DESIGN ADVISORY BOARD Tuesday, August 22th, 2017 at 3:00 PM Conference Room 12, City Hall, Burlington, VT Agenda

1. 18-0059CA/CU; 308 Main St (RH, Ward 8E) 308 Main Street LLC

MEMORANDUM

To: The Design Advisory Board
From: Mary O'Neil, AICP, Principal Planner
RE: ZP18-0059CA/CU 308 Main Street
Date: August 22, 2017 Continued review

PROPOSED FLOOR PLANS

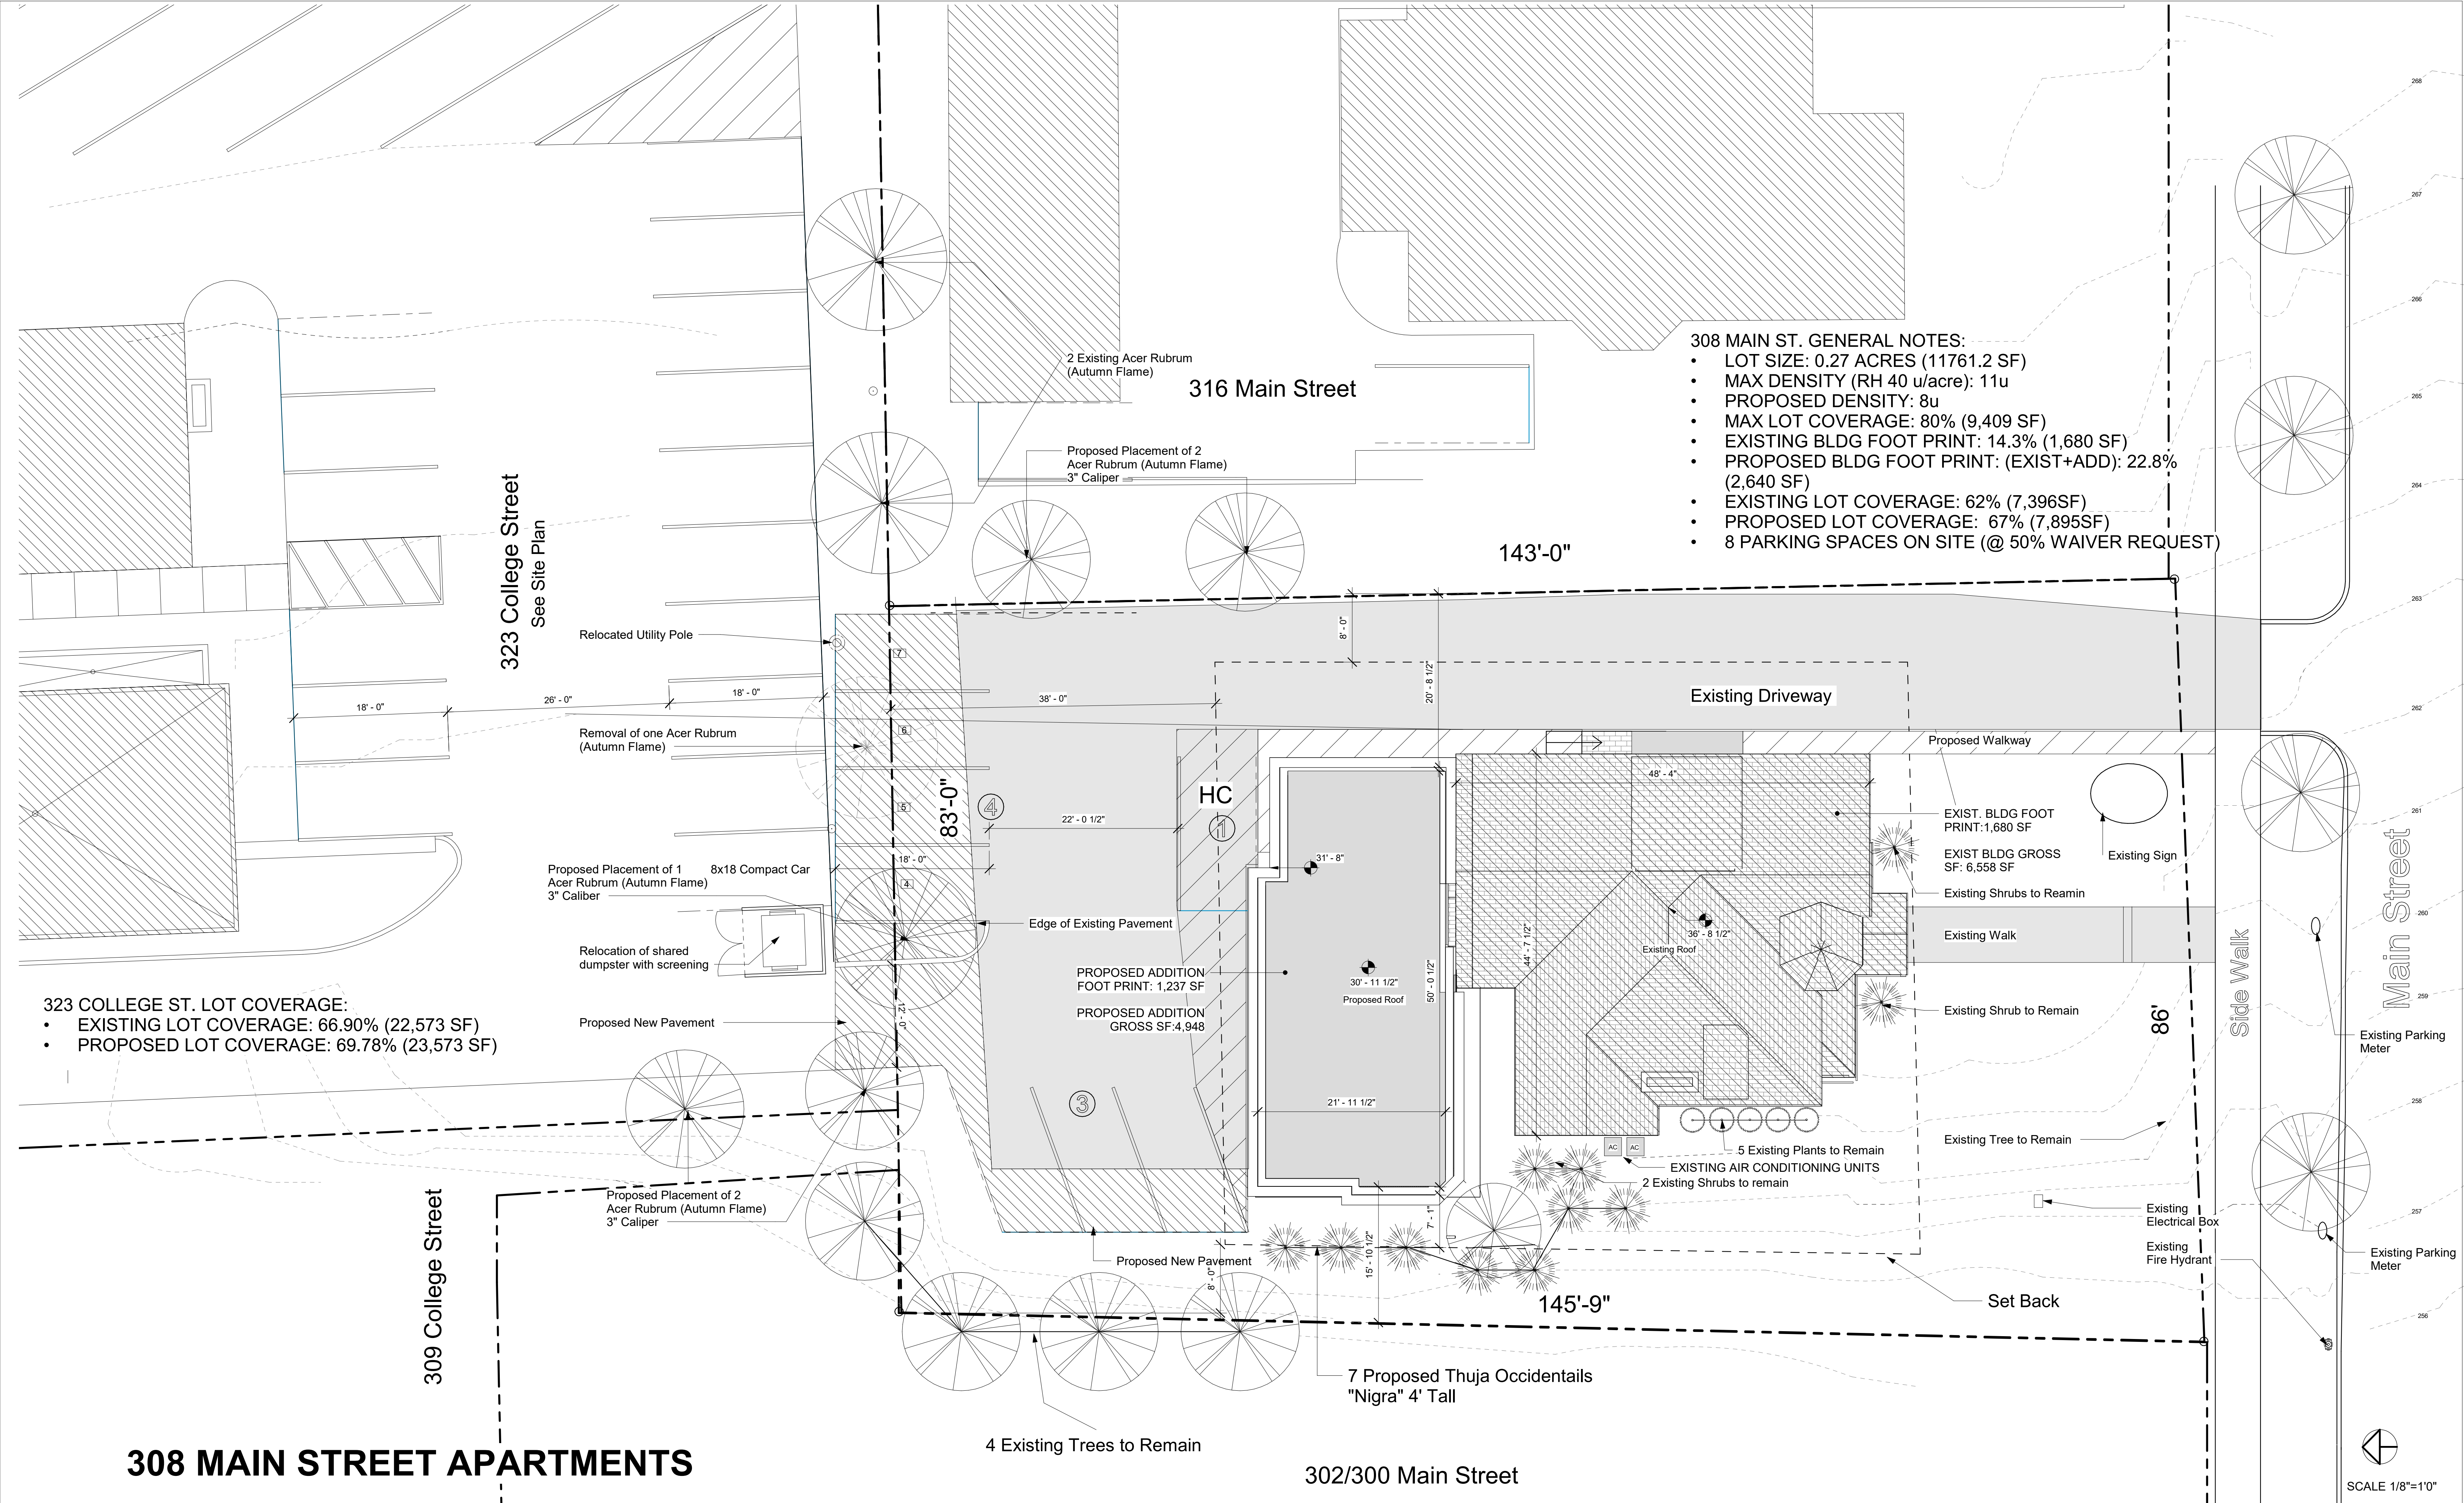
The proposed addition is entirely self-enclosed; there are no apparent new exterior doors accessing the new building mass. A general entry will be provided on the east elevation. That existing covered entrance porch has been walled off so as to face the rear (north) of the property, accessible from the parking lot. Building elevations must include access stairs, which will be essential to gain entrance.

Revised plans illustrate a modest connector between the existing building and the proposed new addition.
